CUSTOMER COMPLAINT - CHANGE IN INSPECTION METHOD

1a.13 Cannot Assemble

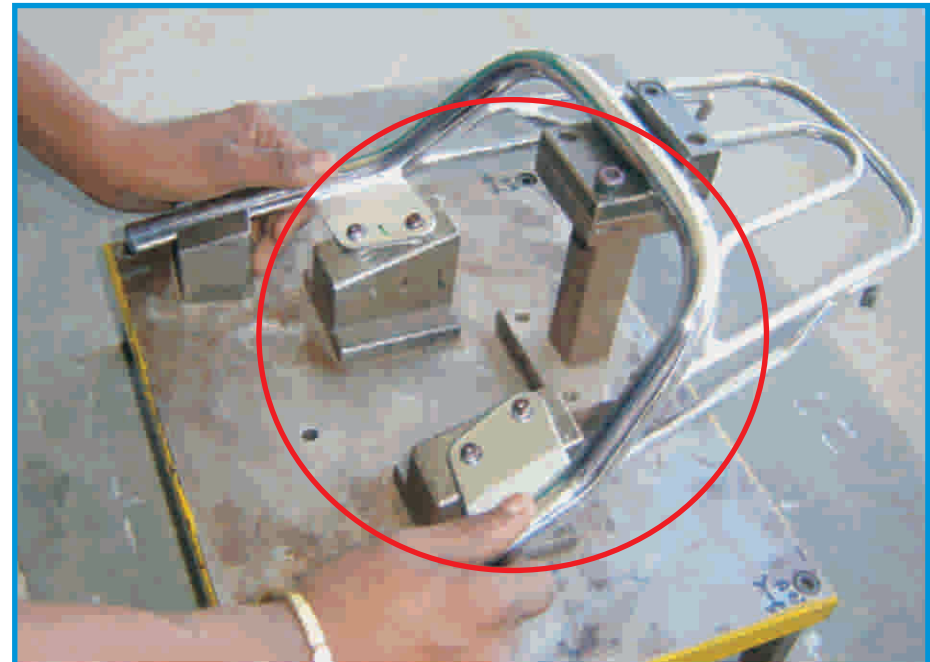
Physical Phenomenon : **Wrong Mounting Position due to Twist**

Before

SAMPLING INSPECTION

BY RELATION GAUGE

After

100 % INSPECTION BY RELATION GAUGE
